Subject : Elevator drive

Affected : Sailplanes model "Club-Libelle 205" } F.R.G. Type Certif.
"Hornet" } No. 304
"Mosquito" } F.R.G. Type Certif.
"Glasflügel 304" } No. 318
- all variants, all serial numbers

HR - Antrieb
Elevator drive bracket

205-33-9

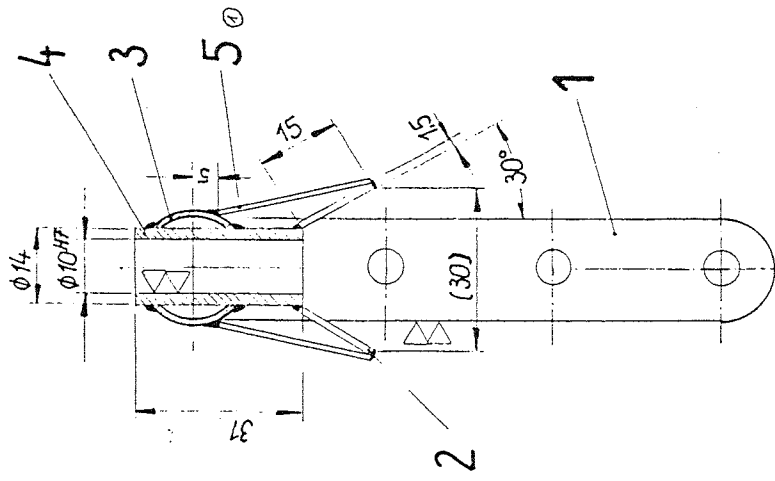
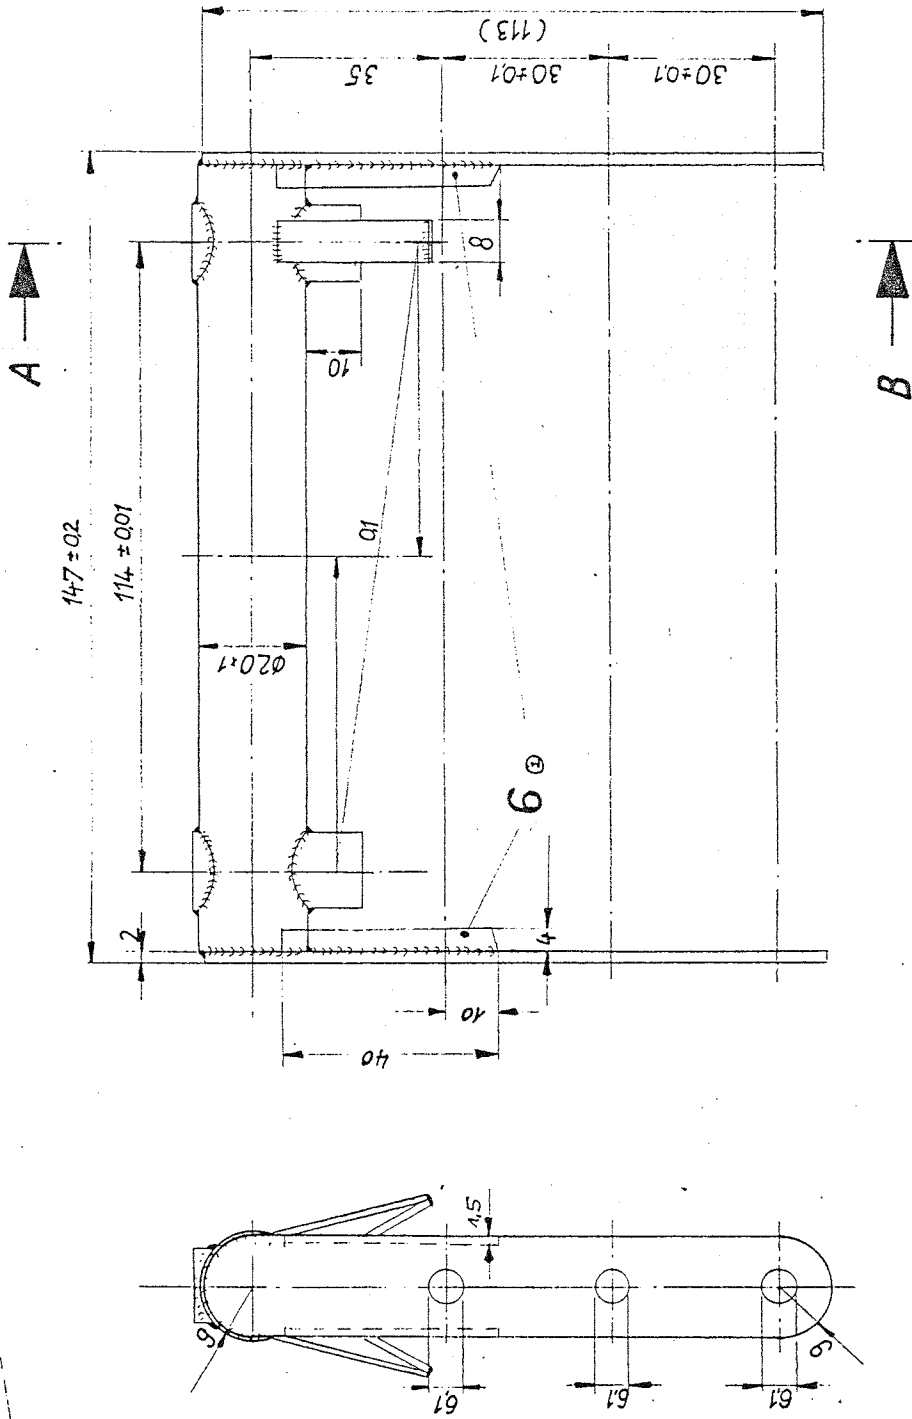
Reason : Difficulties in the control of the sailplane were encountered when an elevator drive bracket broke on one side in flight.

Actions : 1. On sailplanes having an earlier type elevator drive bracket (without reinforcements identified as part (5), modif. 2, on the drawing shown overleaf), a visual inspection for possible cracks in the bracket arms must be carried out. It must also be checked that the bracket arms are not twisted out of line.
2. On sailplanes having an earlier type elevator drive bracket (without reinforcements), the bracket must either be reinforced according to the drawing shown overleaf or be replaced by a reinforced bracket. When the tailplane is re-assembled, it must be made sure that the correct number of spacing washers are fitted between the bracket arms and the ball bearings (tag washers when removing the bracket).

Materials : The reinforced elevator drive bracket, manufactured according to drawing No. 205-33-9 (modification 2) or the additional metal strips with welding wire 1.7734.2 may be obtained from:
Hansjörg Streifeneder
Glasfaser-Flugzeug-Service GmbH
Hofener Weg
7431 Grabenstetten
Federal Republic of Germany

Note : Welding according to drawing No. 205-33-9 (modification 2) must be done by a licensed aircraft welder.
Accomplishment of action 1 must be done by a skilled person.
Accomplishment of action 2 must be entered in the sailplane's log by a licensed inspector.

Fitting drilled with drilling jig
Ream drilled hole 10H7 with device
after welding
For dimensions see DIN 7168 medium range

TIG welding with filler metal 1.7734.2 ge-
schwellig. Grundiert mit Wash-Primer 42002 + Härter
40018. Decklackierung mit Nitro-Lack grau RAL 7003,
RAL 7003 or cadmium-plated

Produced	10.83	H. Str.	
Wachsfertigung ab 1983	13.6.75	U. W. S.	
Abw.Nr.			
Betr. W. Nr.			
Pos. 6 nachgetragen	added		
Pos. 5 nachgetragen	added		
Änderung			
Datum			
Name			
Antr. Nr.
